Net Zero Grid Pathways 1

Major Capex Project (Staged) updated

Attachment I: Summary of Commerce Commission RFIs and responses

Date: 25 September 2023

Figure 2 - Factual vs counterfactual generation for new projects, by region, and for the Growth Scenario (only differences greater than 50 GWh shown)

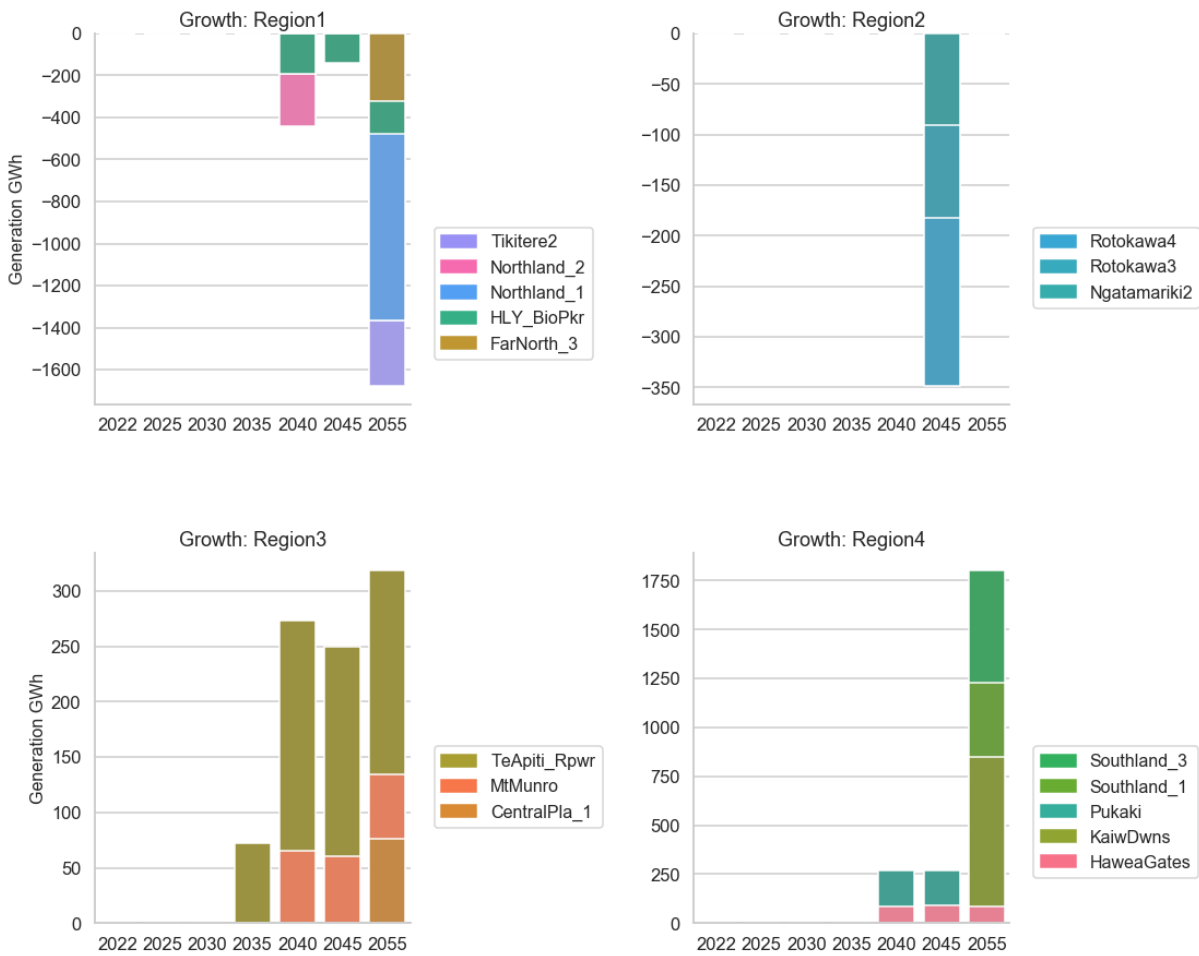
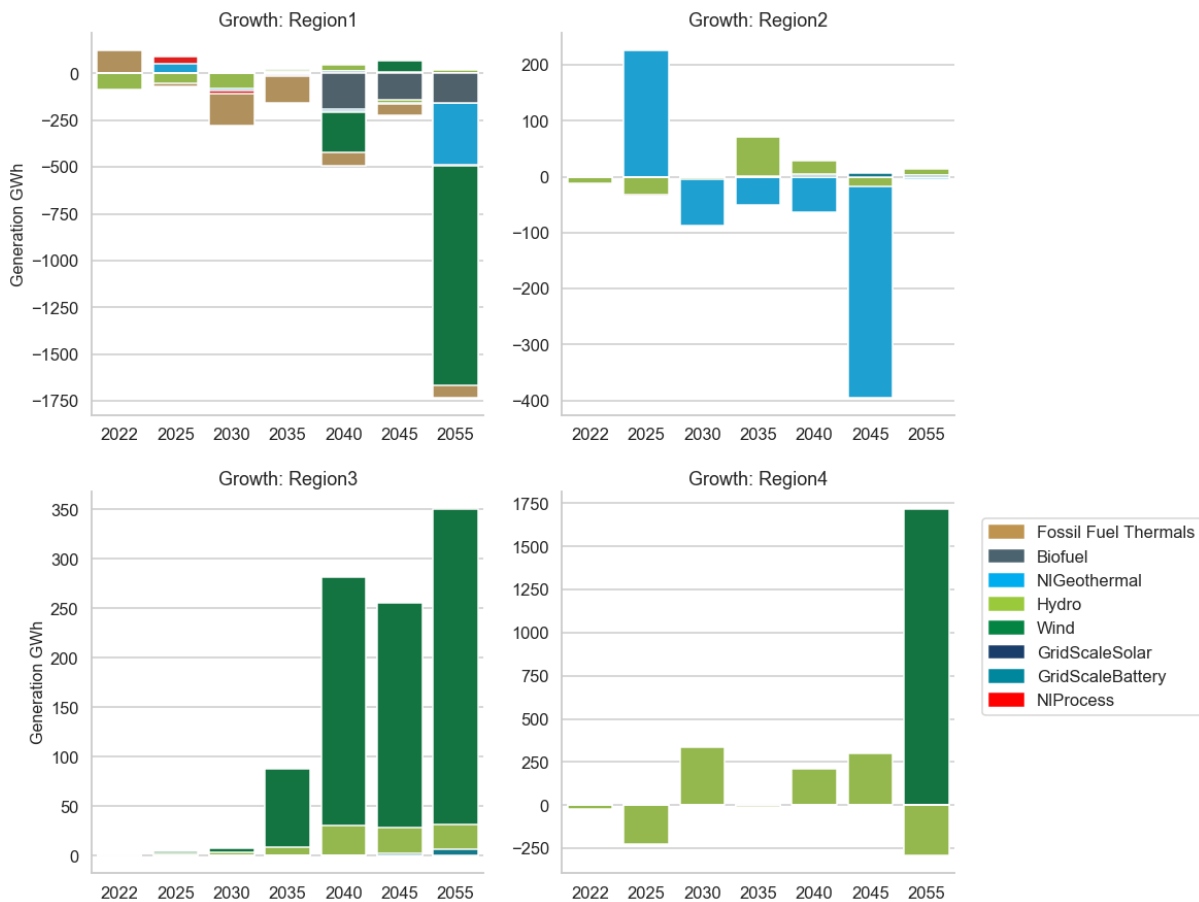
2.1.1 Question 1

Figure 2 shows project generation differences between the factual and counterfactual by region for the Growth scenario. A positive generation difference is where dispatched generation in the factual is greater than dispatched generation in the counterfactual for a given project. We have only shown differences in projects where these are greater than 50 GWh per year (to avoid cluttering the charts). We also provide a spreadsheet with results for the remaining scenarios.

Post 2030 new wind and hydro projects in both Region 3 and 4 contribute to increased generation from these regions compared to the counterfactual. This is similar across most scenarios, although the number of and specific project does vary. After 2040, there is correspondingly less contribution from new generation in Region 1 and 2 compared to the counterfactual.

Changes in generation reflect differences in the factual and counterfactual generation expansion plans. Our factual has more generation built in Region 3 and 4 and less in Region 1 and 2, as compared to the counterfactual.

For completeness Figure 3 shows generation differences between the factual and counterfactual for all plant (existing and new) and for the Growth Scenario. This shows increased hydro generation in 2030 for Region 4 (and some other years). South Island (Region 4) hydro generation has increased as greater HVDC capacity allows greater Northwards transfer of this generation when water values (or the opportunity cost of water) are lower than thermal operating costs. Figure 3 shows generation differences compared to the counterfactual for a mean year. Hydro generation differences are likely to be greater for wetter years.

Figure 1: Transfer limits without and with Huntly–Stratford protection limit

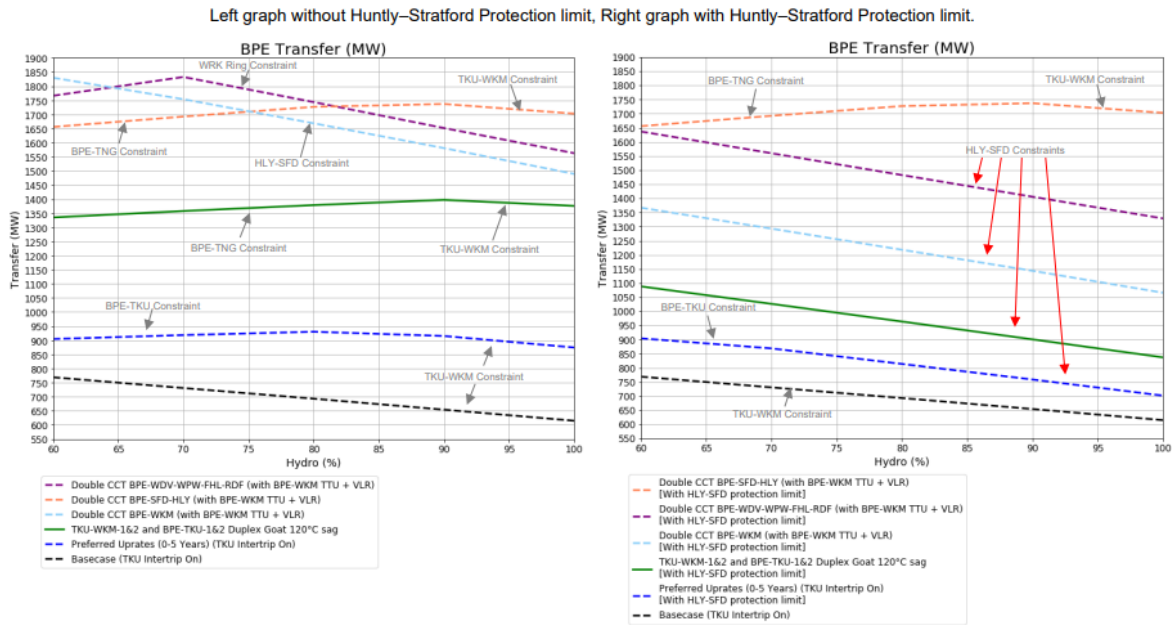
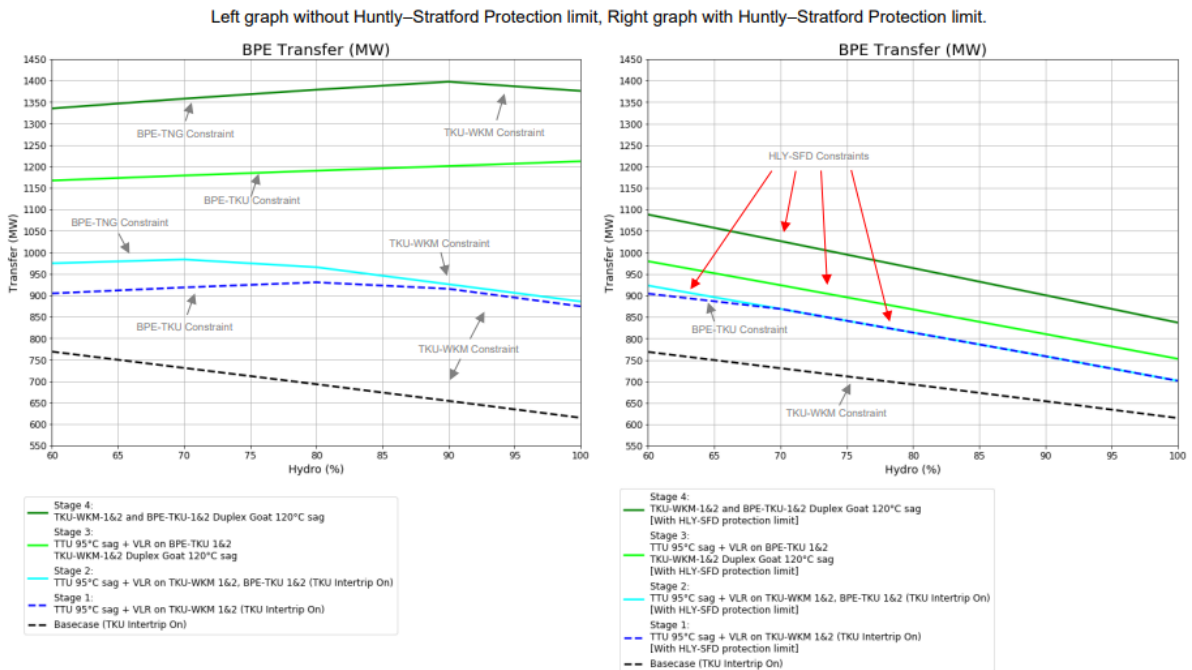
Do all limits assume the HLY-SFD protection limit is removed? Please show constraint set by the HLY-SFD circuit before the protection upgrade.

In Figure 1 and Figure 2 the Huntly–Stratford circuit constraints which have developed when the protection limit is removed have been marked with red arrows.

Figure 1 shows a reduction in Bunnythorpe transfer (MW) when the Huntly–Stratford protection limit is in place for all simulations except:

Figure 2 shows a reduction in Bunnythorpe transfer (MW) when the Huntly–Stratford protection limit is in place for all simulations except:

- The black trend, the Basecase simulation. The Basecase simulation has the Huntly–Stratford protection limit applied in all graphs

Figure 3: Transfer limit when a new 220 kV double circuit line is built between Bunnythorpe and Whakamaru and the existing Tokaanu–Whakamaru and Bunnythorpe–Tokaanu 220 kV circuits are duplexed.

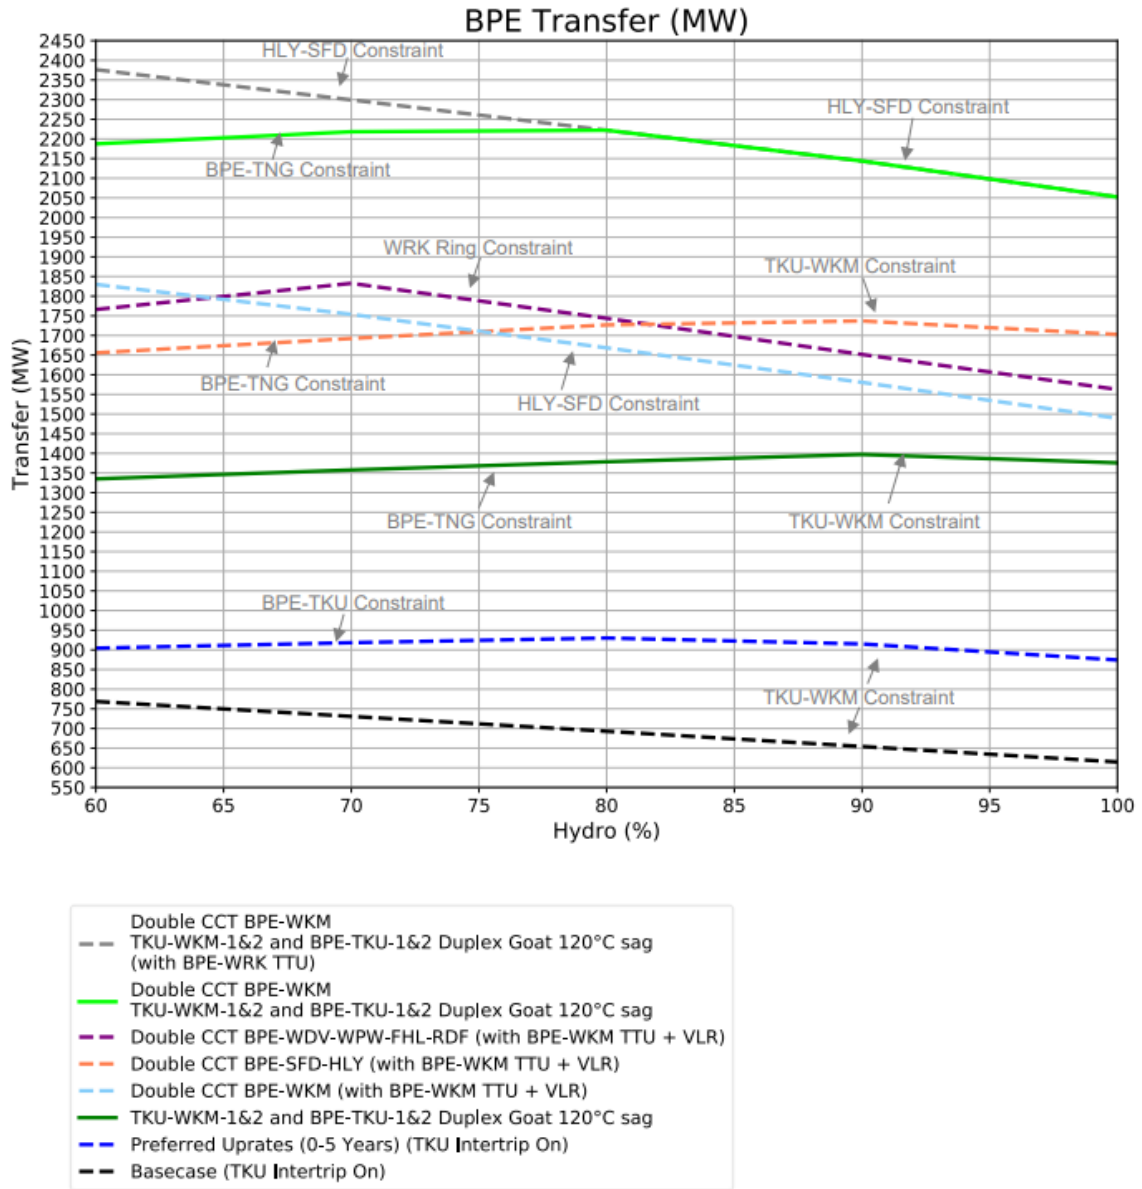
Please advise the expected north transfer capacity after the new line is built. We realise that the new line is not fully specified so also provide the assumptions/parameters of the new line used in the modelling? Grid Planning has advised that the transfer capacity of the new line in the MCP proposal Attachment B does not reflect the effect of all the major capex outputs that would be delivered by stage 1.

The transfer limit is shown by the lime green trend in Figure 3 below. The Bunnythorpe–Tangiwai 220 kV circuit limited the transfer at lower hydro dispatch values. To resolve this a TTU was applied to the Bunnythorpe–Tangiwai, Rangipo–Tangiwai and Tangiwai–Wairakei 220 kV circuits. This has been considered by the Transpower lines team, and it is feasible. It’s assumed the cost to complete the TTU work would be small compared to the cost required to build a new line and duplex the Bunnythorpe–Tokaanu and Tokaanu–Whakamaru 220 kV circuits. The new transfer limit is shown by the dashed grey trend.

The two new transfer limits (lime green and grey) are approximately 2200-2300 MW and have increased from 1700 MW. Approximately 1700 MW was achieved in previous new line studies² without duplex reconductoring (the purple, light-blue and orange trends in Figure 3). Table 3 shows indicative capacity values for clarity.

Figure 1: A breakdown of deficit costs by tranche

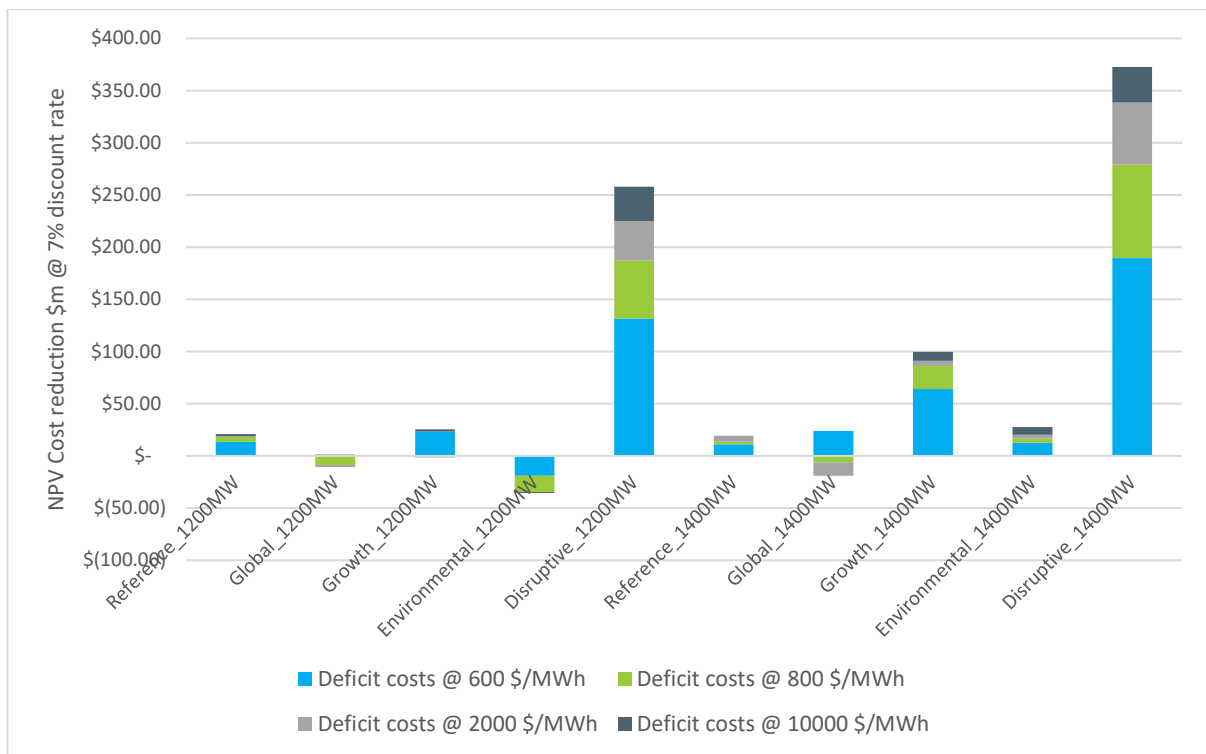
7.1.2 Question 2

Figure 1, below, shows deficit cost reductions, by tranche, for Tiwai leaving in 2024, and our proposed upgrades. Most deficit cost reductions are the associated with demand response.

Figure 19: Preferred option gross benefits over time, Tiwai leaves 2024, HVDC fourth cable 2027

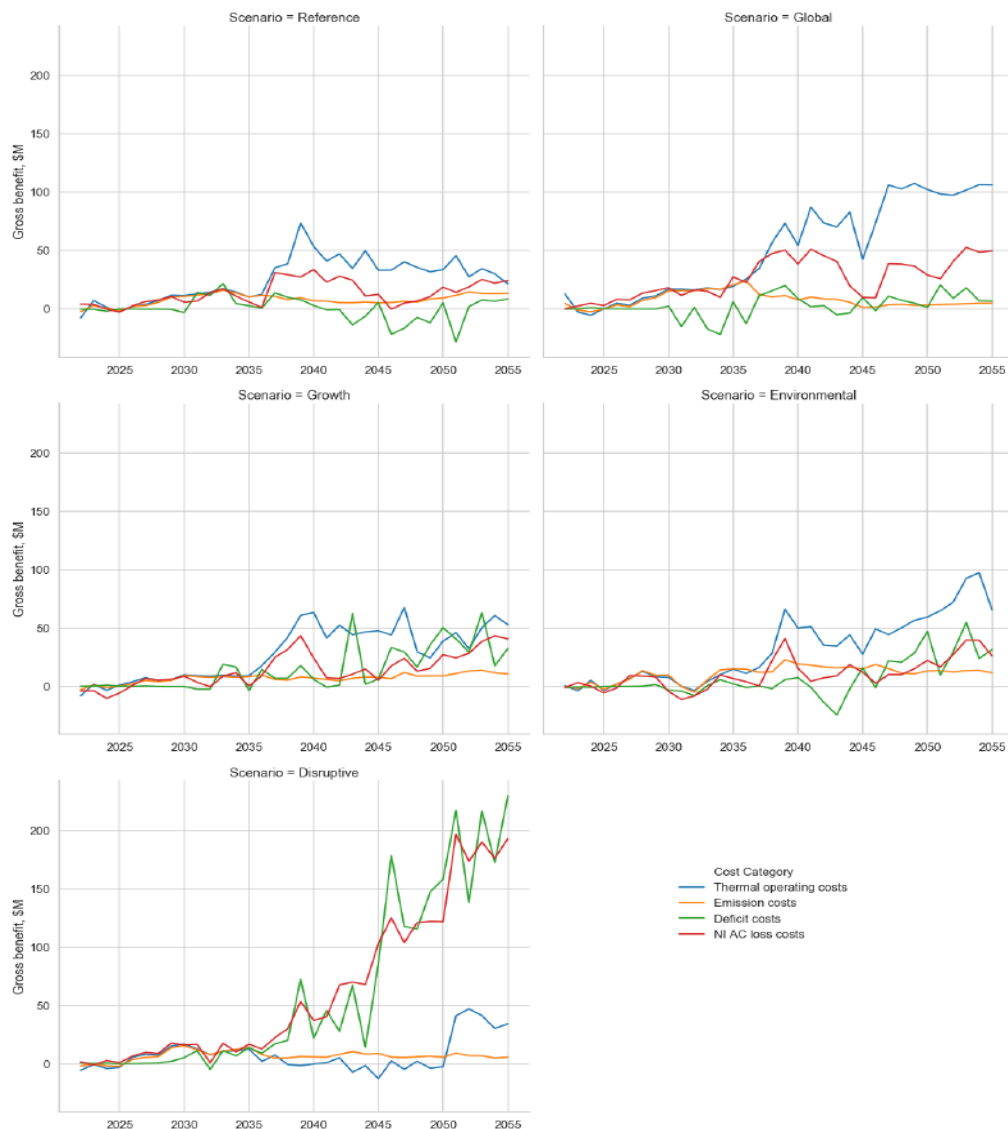
Figure 19 shows your estimated benefits over time. As seen below, there are little benefits until 2035 and most of the benefits come after 2035.

- a. *The results in Figure 19 suggest that Tiwai exit is not providing any significant benefit. Otherwise your calculations will show significant benefits from 2024. Please provide us with your annual calculated benefits, if available.*

Annual calculated benefits for Tiwai leaves in 2024 are attached. As with Figure 19, annual benefits are undiscounted.

Figure 4: Factual vs. counterfactual generation for average and wet year South Island hydro generation

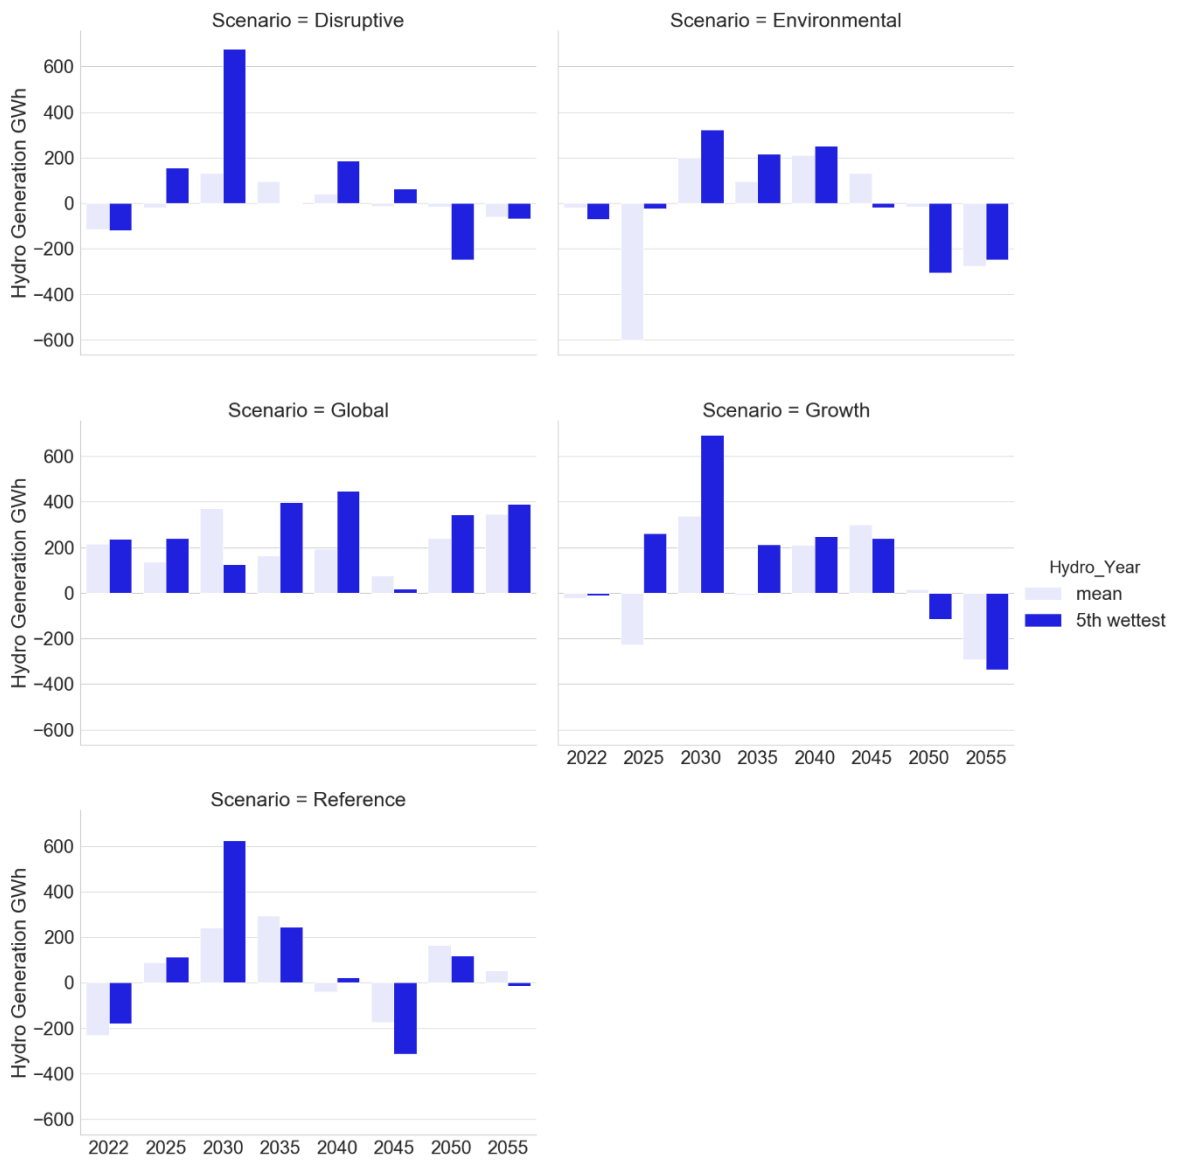
- b. *Would there be any material market costs if Tiwai exits and Transpower does not upgrade the HVDC? I.e. did the SDDP results show any spill costs? Spill costs are not shown in the spreadsheet, but we understand they may be included in the thermal operating costs. Our initial assessment is that any spill costs would be very low because the thermal operating benefits are low until 2035. Please note that the upgrade can only save up to the increased capacity (120 MW) of spill rather than all the generation that is constrained.*

Greater South Island hydro generation in our factual is largely associated with wet years, when expected inflows are likely to be high, implying water values less than the unit thermal costs. To demonstrate this, Figure 4 shows average and wet year South Island hydro generation differences between the factual and counterfactual for all scenarios. As is our convention, a positive generation difference is where dispatched generation in the factual is greater than dispatched generation in the counterfactual.

Figure 4 shows that South Island hydro generation factual differences are mostly greater for wet years compared to dry years. Also, factual differences *occur well after Tiwai exits*. For some scenarios forecast factual differences become negative around 2045, this will be related to new South Island generation projects ‘crowding out’ South Island hydro generation. For these years, while South Island hydro generation is less than in the counterfactual, this is compensated by greater quantities of generation from new South Island renewable generation.
